**Reference: Upper's Grove Subdivision – Proposed Redline Revision
Engineering Technical Brief
Town File No's: D12-01-2019
City of Thorold, ON**

This Engineering technical letter has been prepared in support of the proposed redline revisions to the Upper's Grove Plan of Subdivision, hereafter referred to as the Site. These redline revisions are mainly required to address comments provided by the TransCanada Pipeline (TCPL) following their review of the detailed design drawing submission, as outlined in their letter submitted to the City of Thorold (City), via their planning consultant – MHBC, dated November 17, 2023. TCPL has requested the following revisions:

DRAFT PLAN OF PROPOSED SUBDIVISION
PART OF LOT 67 AND
PART OF ROAD ALLOWANCE
BETWEEN 67 AND 68
 (GEOGRAPHIC TOWNSHIP OF THOROLD)
CITY OF THOROLD
 REGIONAL MUNICIPALITY OF NIAGARA

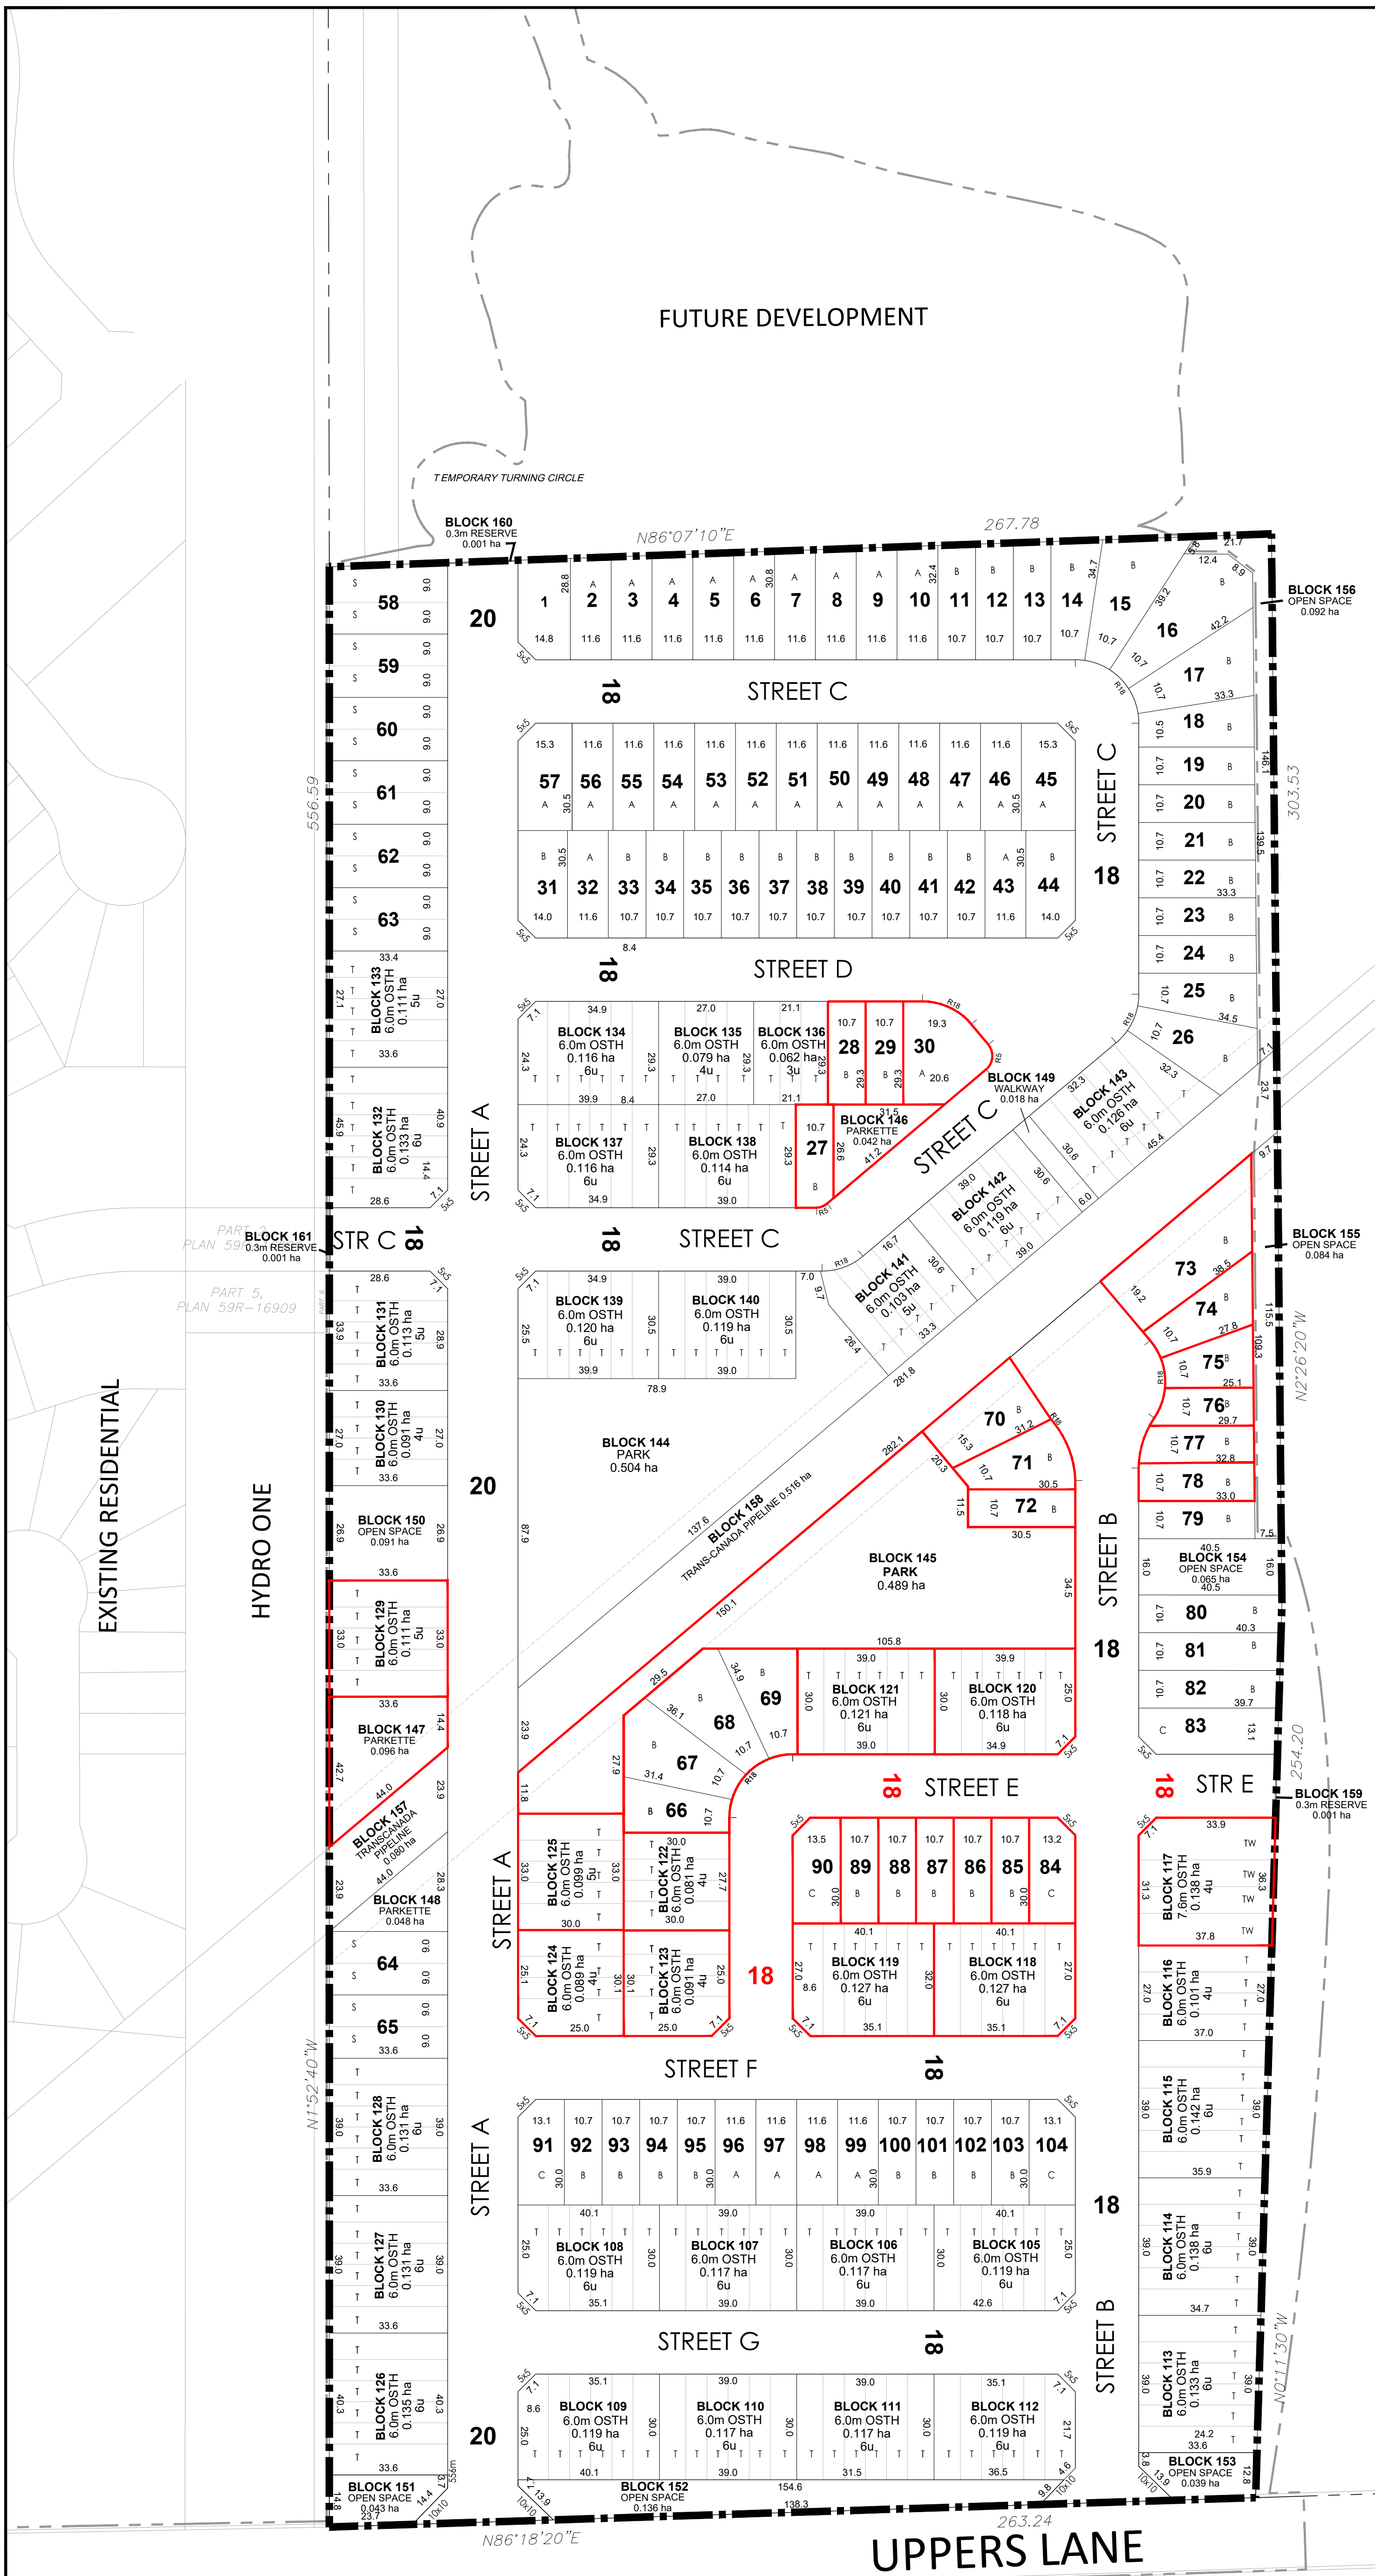
- Street B Cul-De-Sac is moved 7.0m south to avoid the TCPL setback, thereby requiring the reconfiguration of lots 70 – 78.
- The Street E and Street A Intersection has been deleted, resulting in the need to:
 - Realign Street E to intersect with Street F.
 - Reduce the right-of-way width of Street E from 20m to 18m to be consistent with the balance of the Subdivision ROW widths.

- Reconfiguration of lots fronting Streets A, B, E and F
- An increase in park space in Block 145
- Minor revisions to lots 27-30 fronting Street D and Street C
- An overall reduction in unit count from 328 units to 324 units, which includes the following:
 - A decrease in 11.6 m Singles from 34 to 30 units
 - A decrease in 10.7 m Singles from 69 to 61 units
 - An increase in 9.0 m Singles from 0 to 5 units
 - An increase in 6.0 m On Street Townhouses from 204 to 208 units

FUNCTIONAL SERVICING AND
 STORMWATER MANAGEMENT REPORT
 UPPER'S GROVE
 RESIDENTIAL DEVELOPMENT
 CITY OF ENDBURGH, ONTARIO
SS-1
PRELIMINARY
SERVICING PLAN
 May 2025

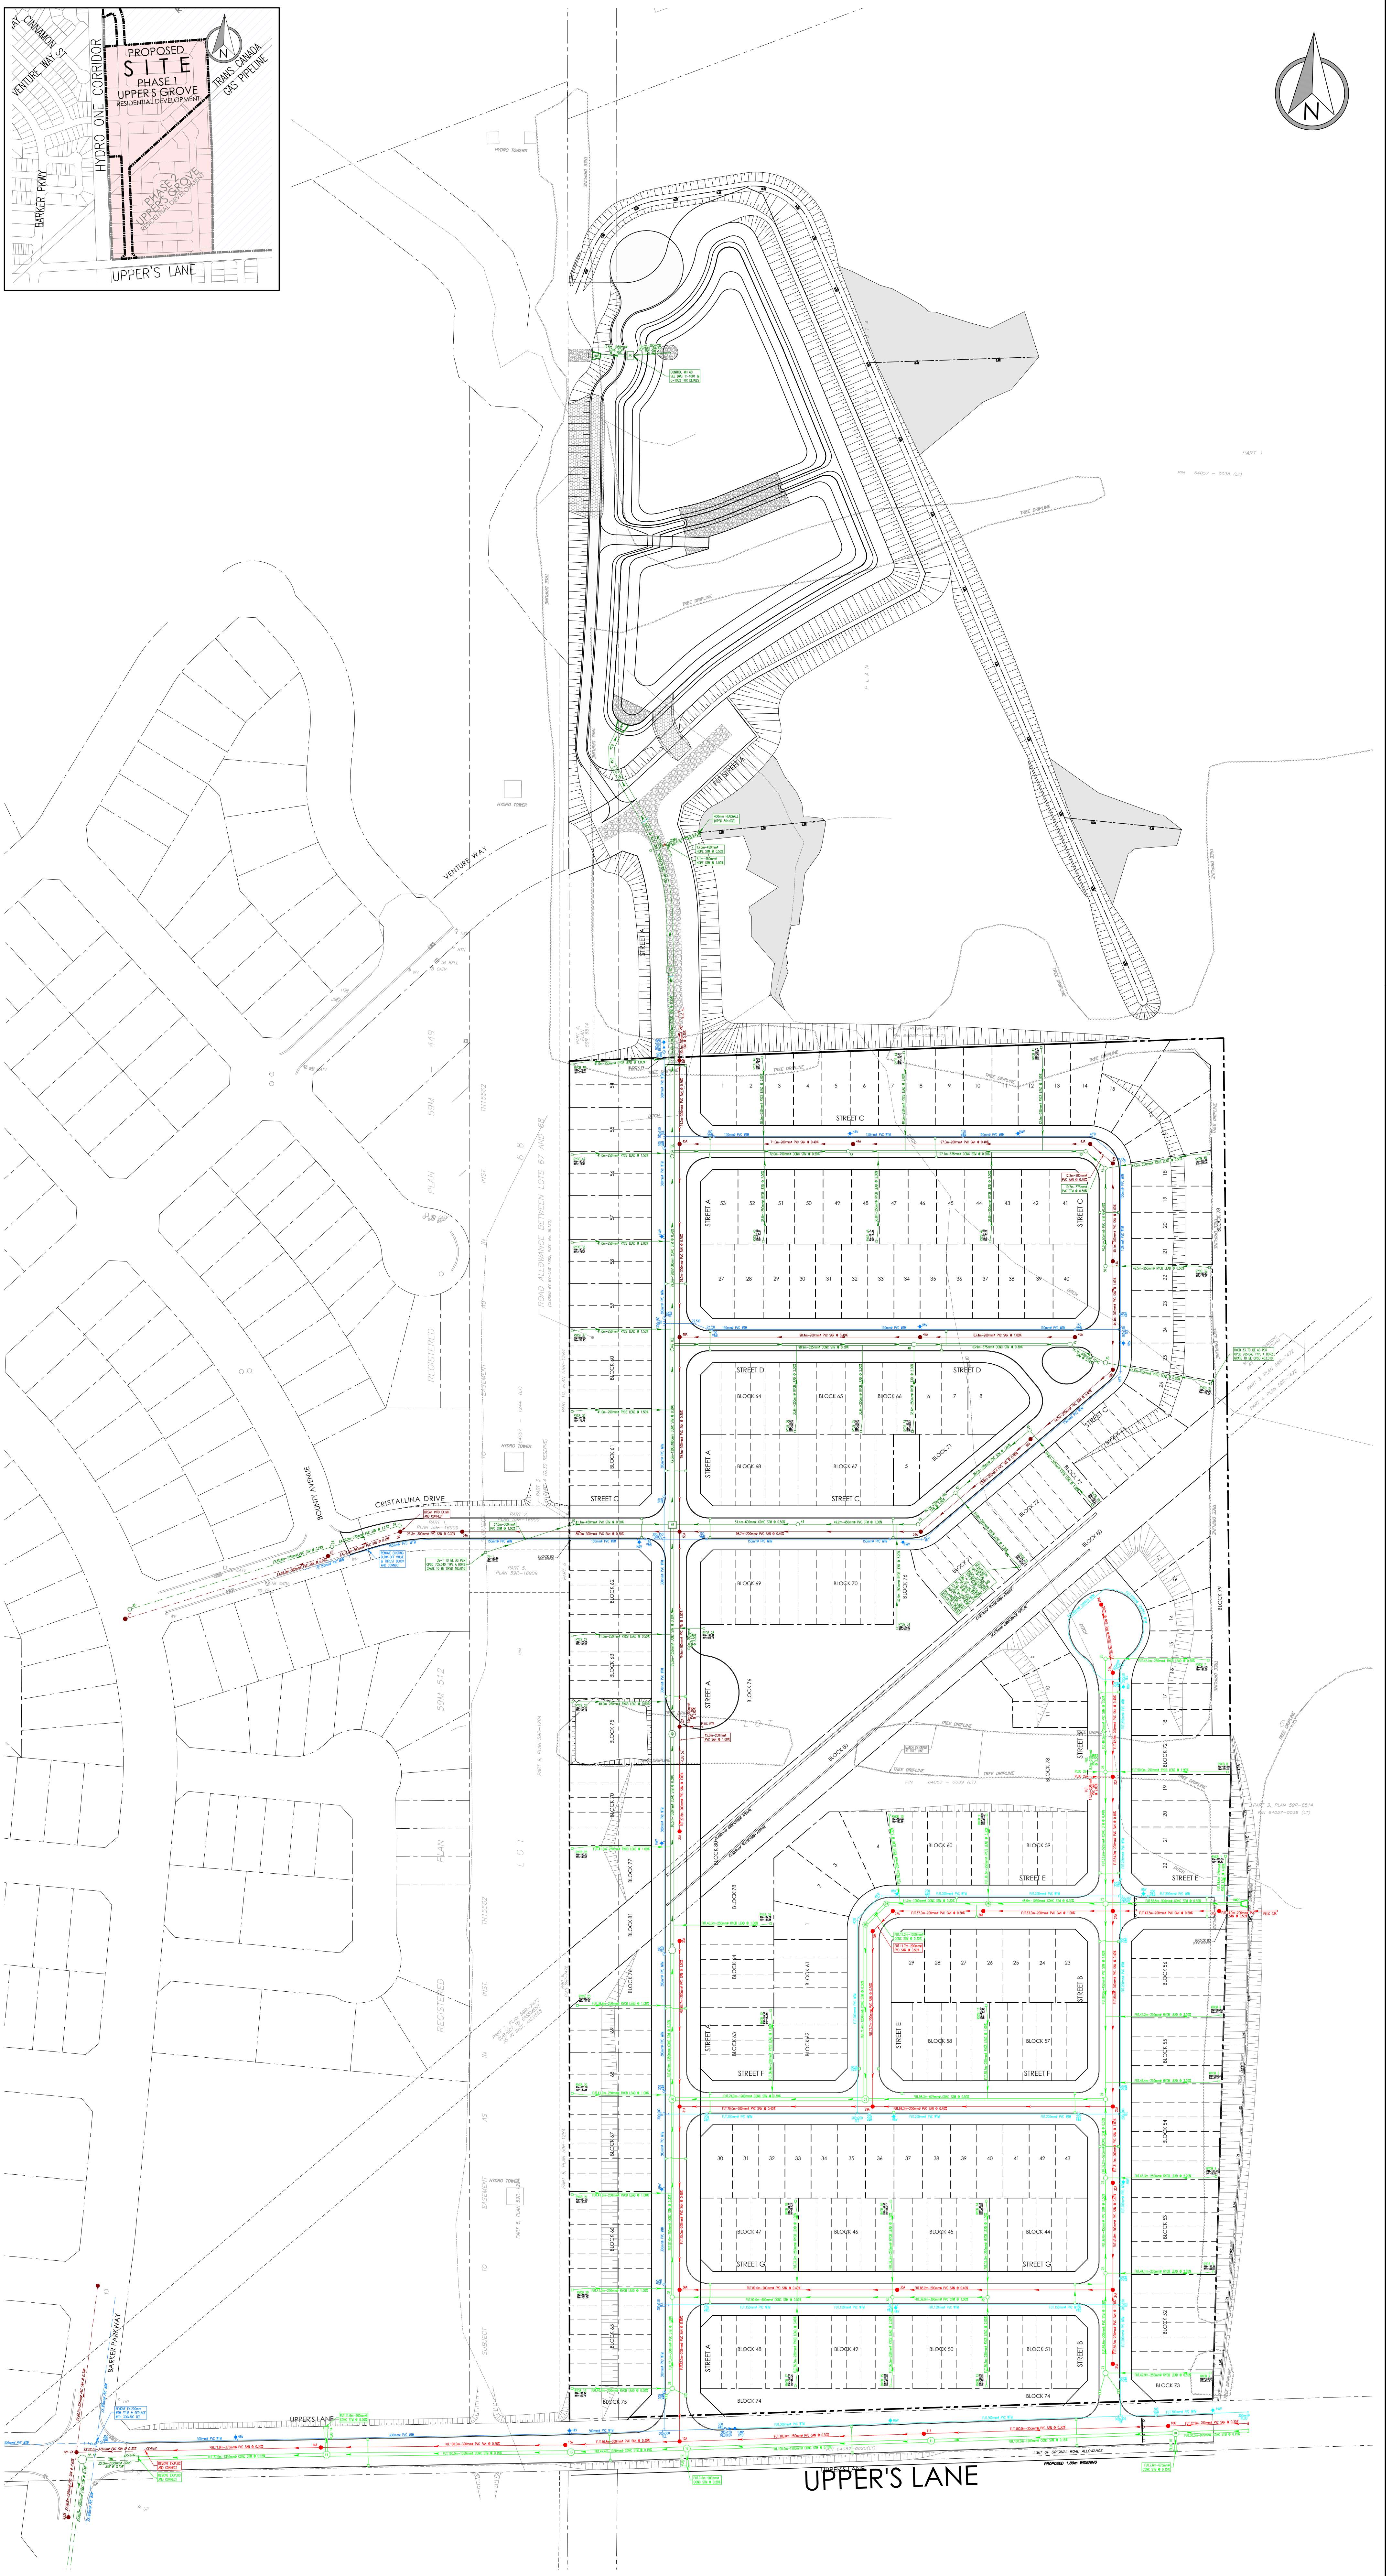
- An overall decrease in the unit count from 328 to 324 and a reduction of Street E width from 20 m to 18 m will result in a reduction of impervious roofs and paved areas. The reduction of impervious areas will reduce the overall runoff contributing flow to the proposed Interim Pond, and therefore, the pond will function as designed.
- Segments of storm sewers along Street E, Street F and Street A are to be upsized and realigned to accommodate the new alignment of Street E and the associated drainage.
- Given that the general drainage regime has not been altered, and with the reduction of impervious areas, there are no major changes to the stormwater servicing apart from minor upsizing and realignment of the storm sewer and no changes to the design of the interim pond.

- An overall decrease in the unit count from 328 to 324 will result in a reduction of sanitary flow contributing to the sanitary system.
- Segments of sanitary sewer pipes along Street E, Street F and Street A are to be realigned to accommodate the realignment of Street E and reconfiguration of units as illustrated on the attached **Drawing No. SS-1**.
- Given that the overall unit count has decreased, there are no major changes to the sanitary servicing apart from minor realignment of the sanitary sewer system along Street E, Street F, and Street A, due to the realignment of Street E and reconfiguration of units.

- An overall decrease in the unit count from 328 to 324 will result in a minor reduction in the site's water demand.
- Segments of water pipes along Street E, Street F and Street A are to be realigned to accommodate the realignment of Street E and reconfiguration of the unit, as illustrated in the attached **Drawing No. SS-1**.
- Given that the overall unit count has decreased, there are no major changes to the water servicing apart from minor realignment of the water pipes along Street E, Street F, and Street A due to the realignment of Street E and reconfiguration of units.
